Report on Consultation – Alignment  
Dunoon to Loch Long 132 kV OHL Rebuild

November 2022

REF: LT000193-WSP-ENV-RPT-008

Scottish & Southern  
Electricity Networks

Date: Wednesday, November 16, 2022 scale: 18,000 @ A3  
 Drawn: MAL Checked: JA Approved: SM

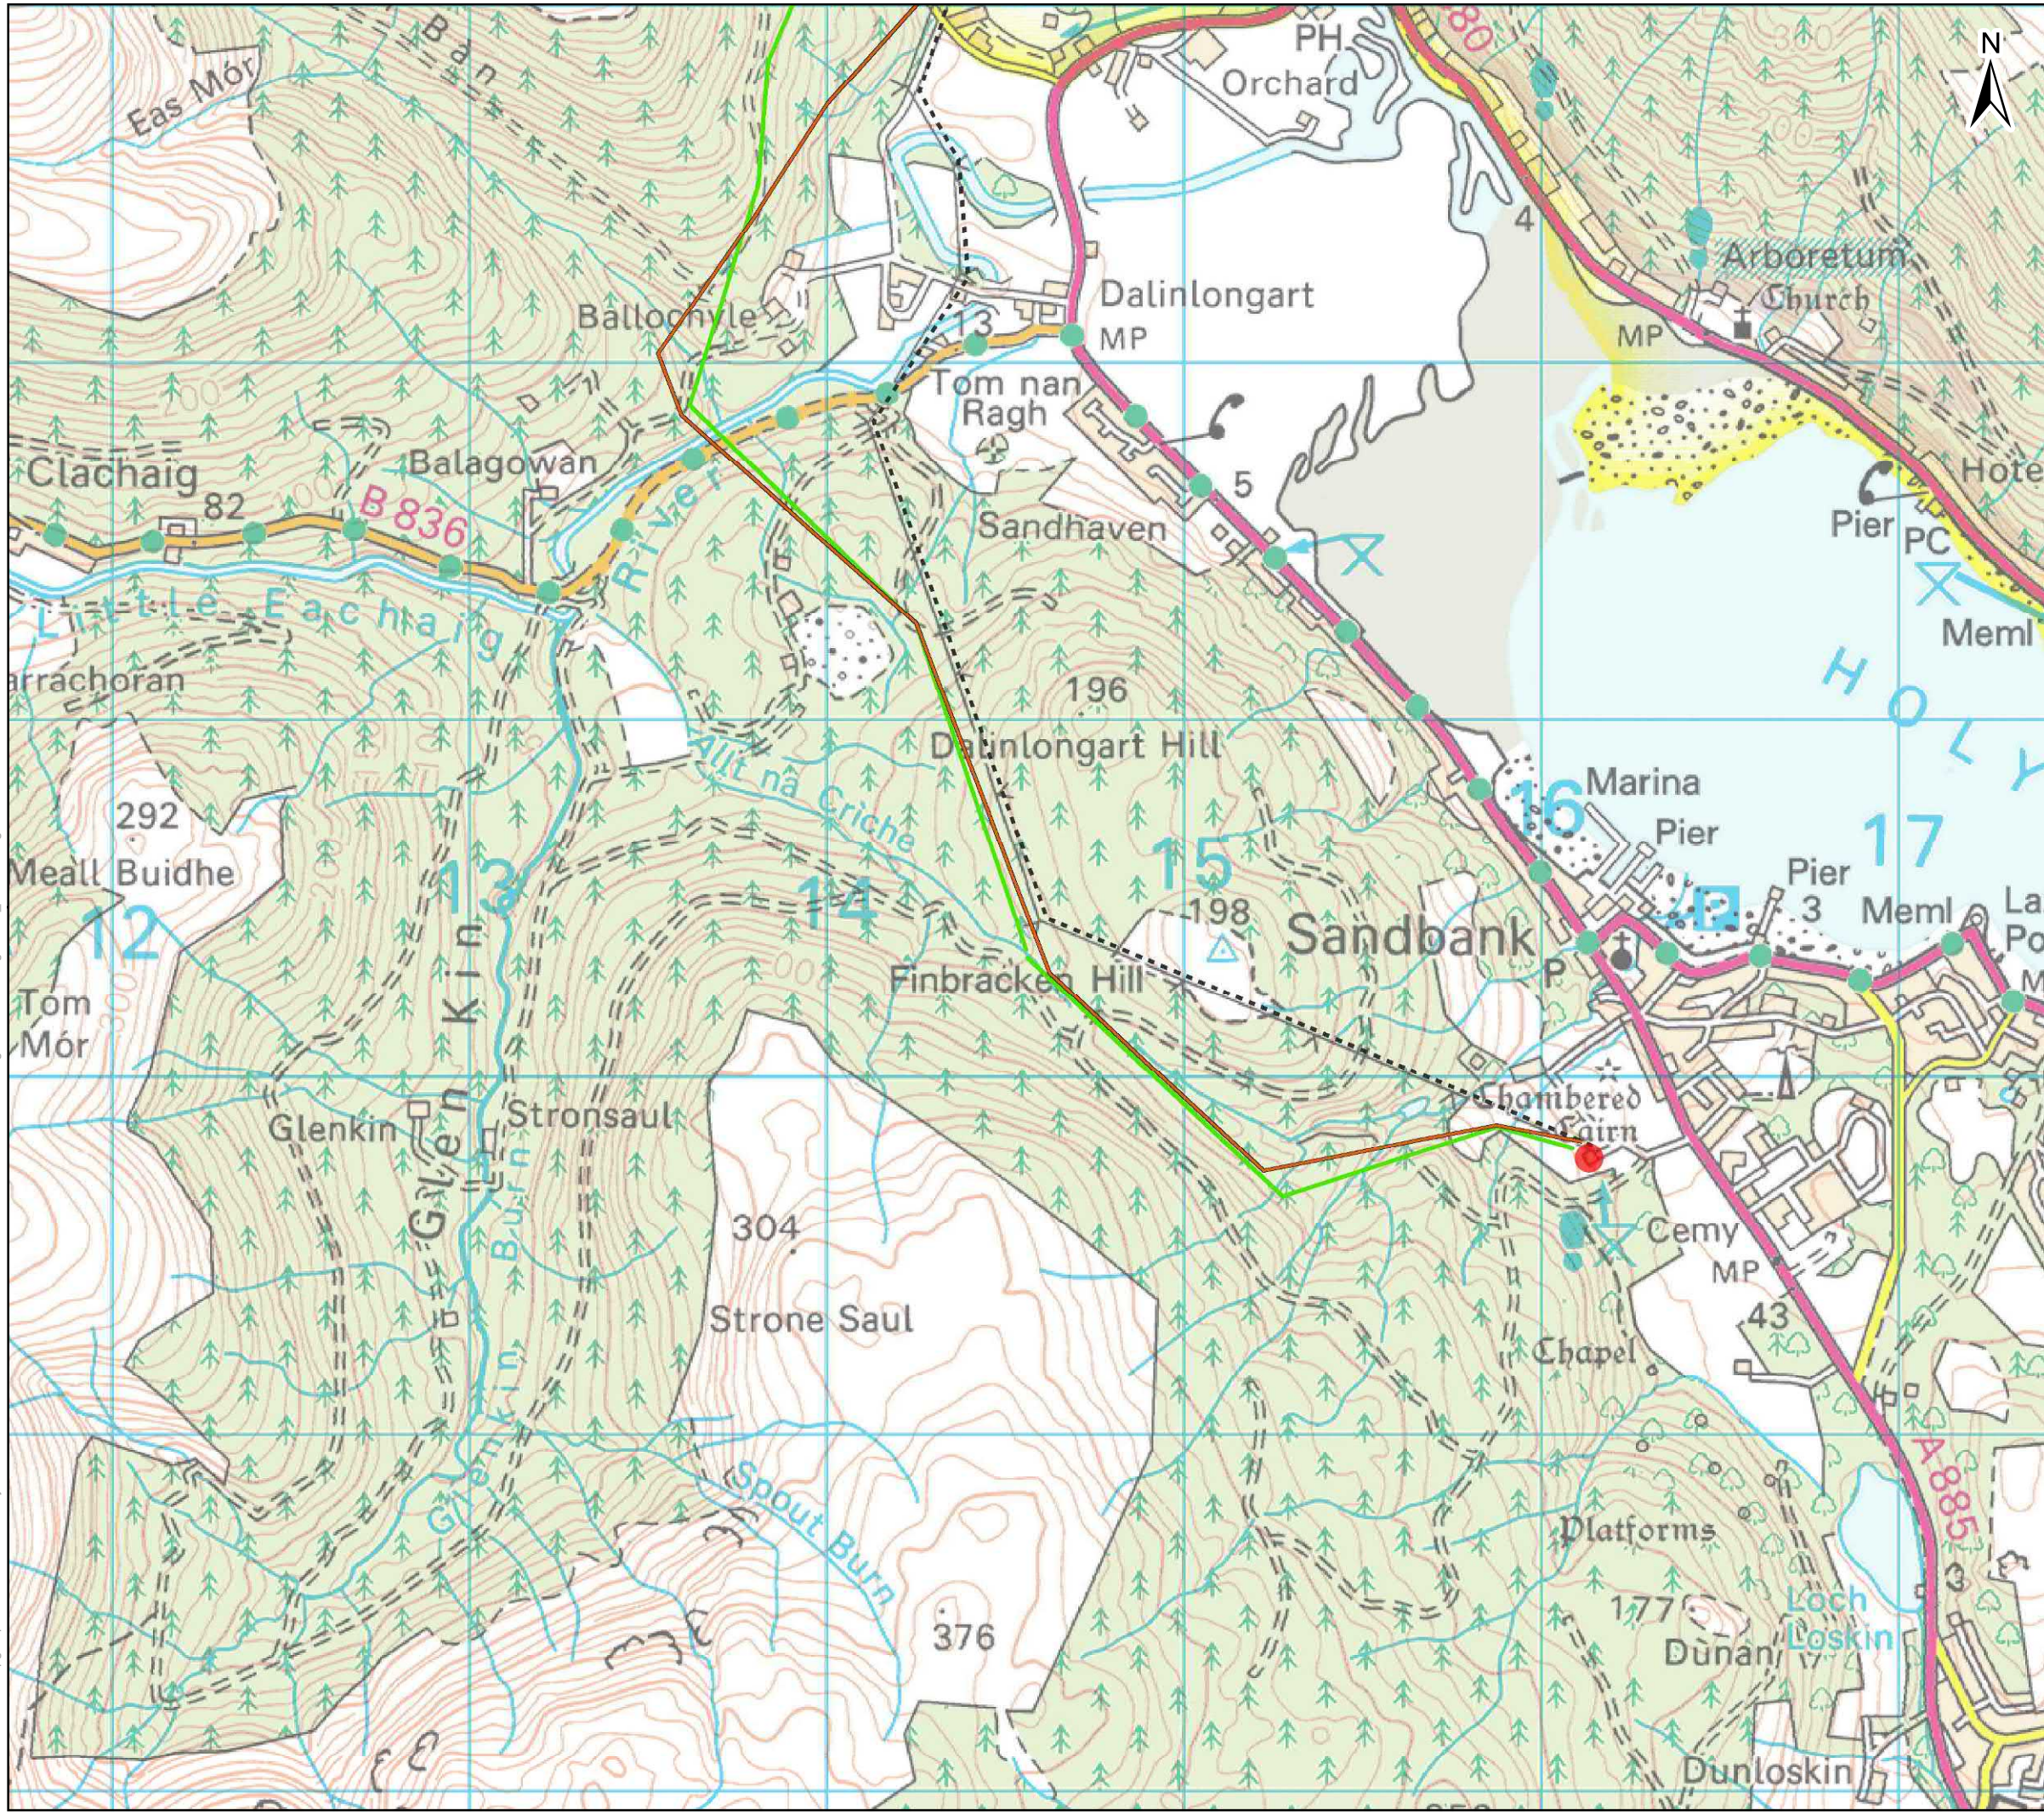
In response to public consultation feedback regarding visual effects within Section 5, during refinement the alignment was moved further away from residences and further up the hill to increase distance from residential receptors.

In response to public consultation feedback regarding visual effects, potential effects on private water supplies and forestry management a deviation to the consulted alignment was proposed within Sections 1, 4 and 5 of the Proposed OHL Route to reduce potential effects.

This revised alignment keeps the OHL down-slope of the PWS sources, thus significantly reducing the risk to these during construction. The revised alignment also significantly reduces the height of the replacement OHL on the landscape, reducing potential landscape and visual impacts to receptors looking across to the hill. By limiting the height of the alignment on the Ballochyle hill, the visual impact on receptors leaving Sandbank/ Dunoon on the main road (A815) will be reduced. During consultation with the Ballochyle community this landscape impact was highlighted as being increased due to the necessary tree felling required to form a cleared corridor associated with the replacement OHL. It is noted that bringing the alignment off the hill sooner, tying into an alignment along 5C would reduce this effect, as well as reducing the length of the replacement line transecting forestry areas, subsequently reducing associated forestry impacts.

The revised alignment also removes partially skylined towers being visible from residential dwellings and moves the alignment of the replacement OHL closer to the existing OHL alignment which was an approach generally supported throughout consultation exercises.
